SUZUKI MECHANICAL SS/TL TRIM READING CORRECTIVE ACTION

Suzuki mechanical rigged boats with SS/TL outboards will not have a functioning trim gauge. Below are the corrective actions needed.

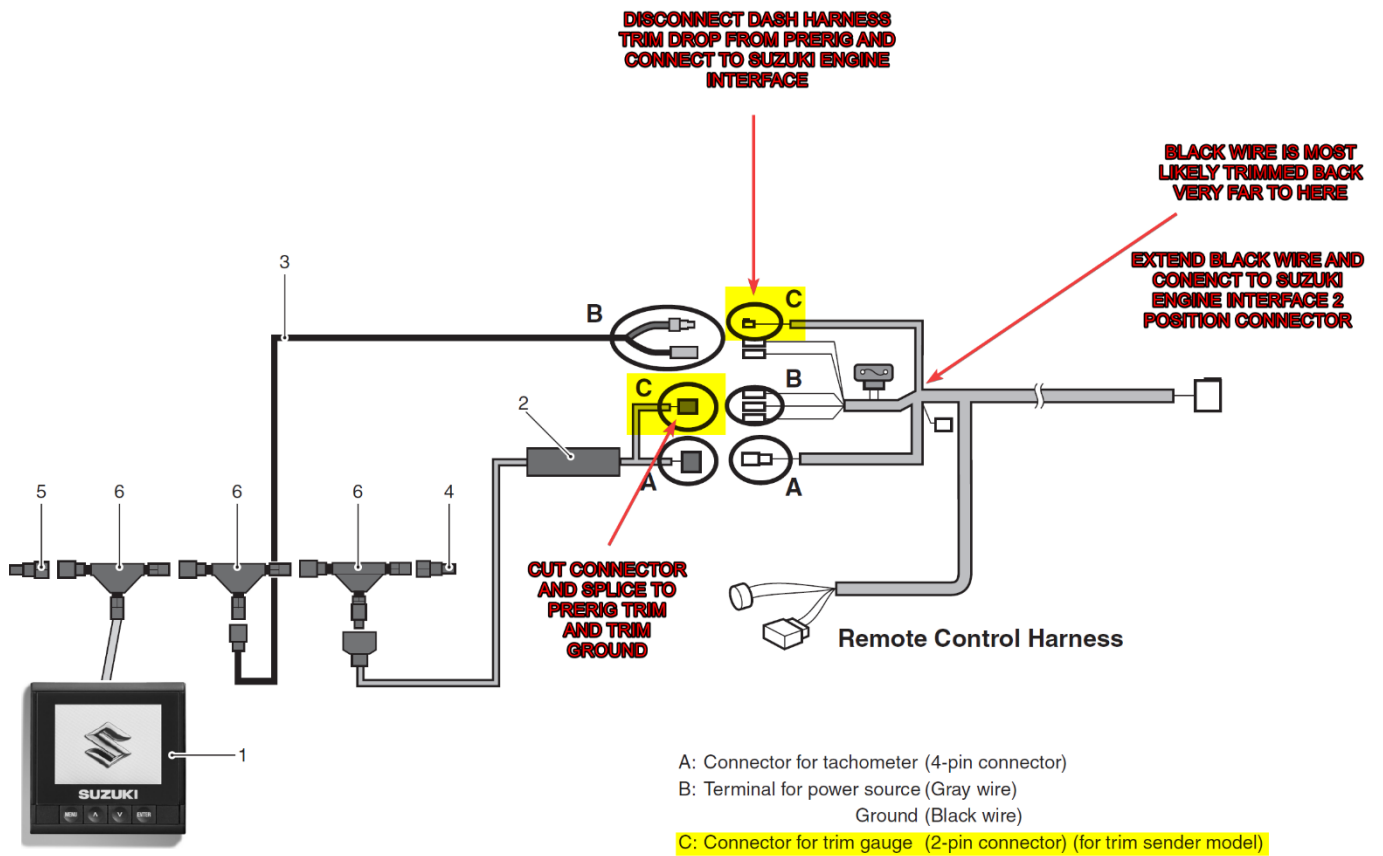
Install NMEA backbone and components as shown below.

In the bottom right-hand corner of the image, you will see it states "CONNECT TO SUZUKI TRIM CONNECTOR ON PRERIG". You can potentially be challenged with this connector not being present in the prerig due to an existing connection that is made to the dash harness to pick up trim traditionally. You will have to connect the prerig trim (white/yellow) and trim ground reference line (black) to the engine interface manually as shown below. If your prerig still has the black wire attached to the connector with the trim wire severed, please reattach, and plug the connector into the Suzuki Engine Interface.

Connect your SDS harness (directional harness, please see tags on each end of harness) to the engine interface and run to the motor. Locate your SDS motor plug and connect the harness to it. Finally, configure your gauge to read Suzuki digital. To do this, please reference the Medallion Analog Gauge Users Guide found on the dealer portal under Manuals/Troubleshooting.
